# PLANNING

Project: **7 Warwick Court**

Drawing Title: **Proposed Section FF**

Drawing No. **P\_15** Rev. **D**

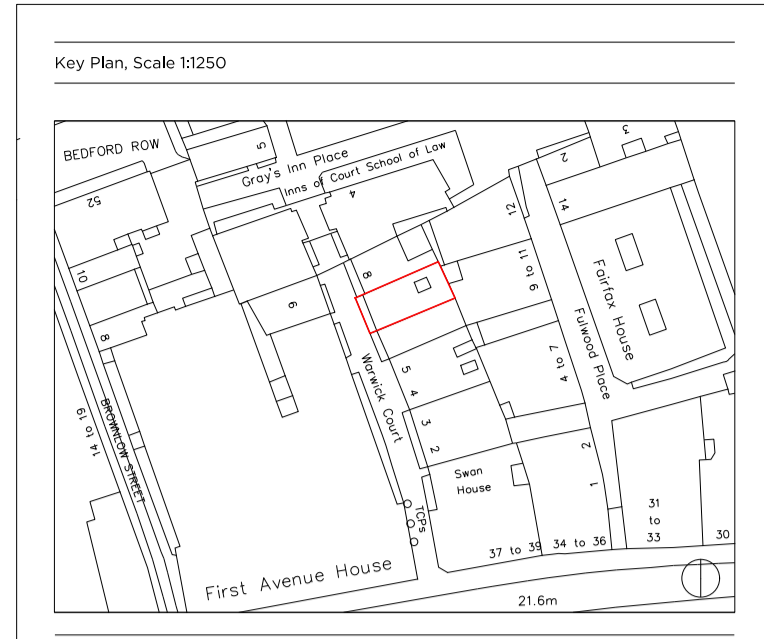
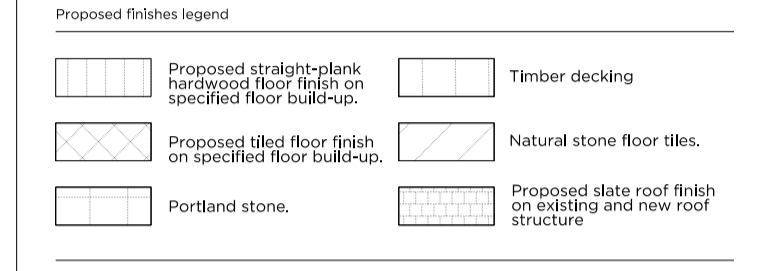
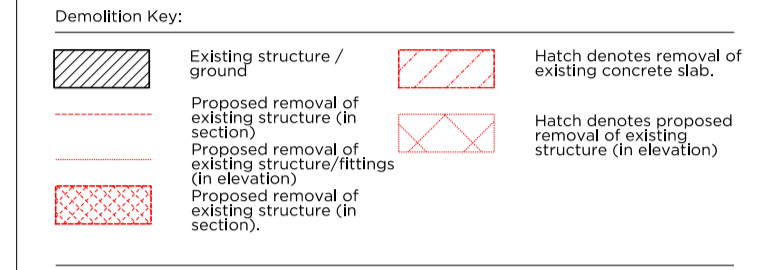
- C. Revision Notes:**
- C.1 Existing roof finishes and structure to be reconstructed.
  - C.2 Existing dormer windows to be retained.
  - C.3 AOV shaft to be repositioned.
  - C.4 AOV Automatic opening vent moved from roof level to rear wall.
  - C.5 Entrance to Flat 05 to be adjusted to begin in hallway.
  - C.6 Proposed shower room.
- D. Revision Notes:**
- D.1 Proposed AHSP's now removed.
  - D.2 Proposed rooflights reduced in height.
